SUM-76/77/8
10.99/11.54/0.00

GENERAL SUMMARY

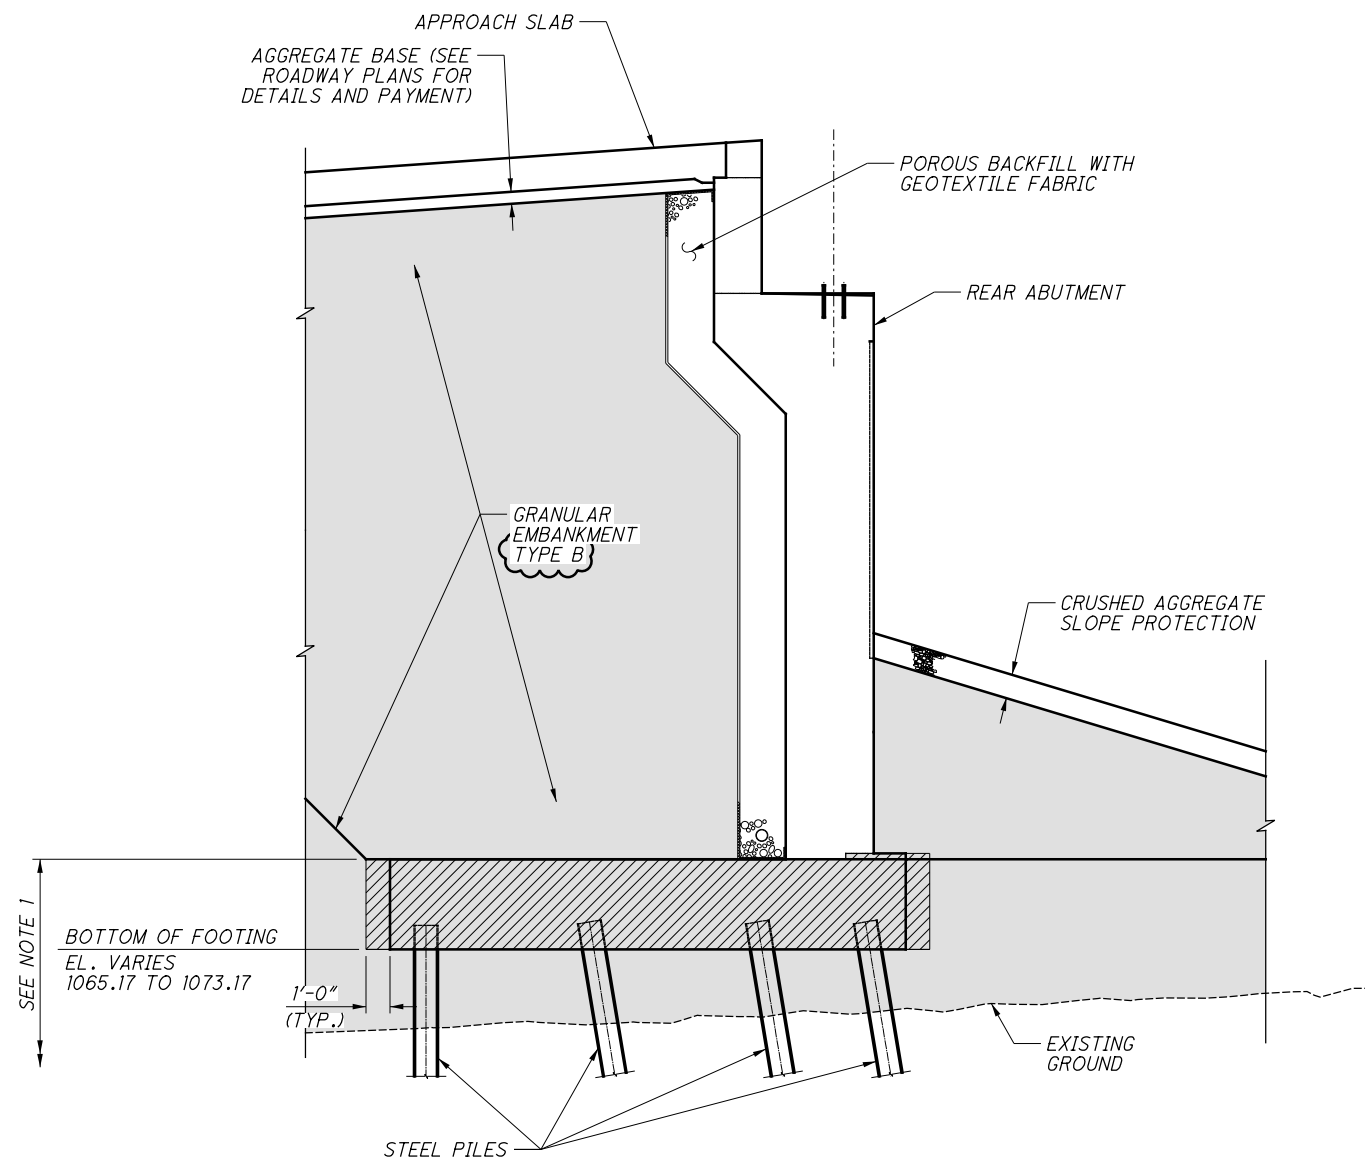
THE EXISTING PIPE TO THE NORTH FROM D31 IS TO REMAIN. THE PROPOSED INVERT OF THE PIPE AT D31 IS UNKNOWN DUE TO THE EXISTING CB RD15 NOT BEING FIELD LOCATED.

CONTRACTOR TO VERIFY INVERT OF EX. PIPE AT D31 AND ENSURE PIPE INVERTS BETWEEN D31 AND D263 PROMOTE POSITIVE DRAINAGE PRIOR TO ORDERING ANY PRECAST STRUCTURE FOR D31.
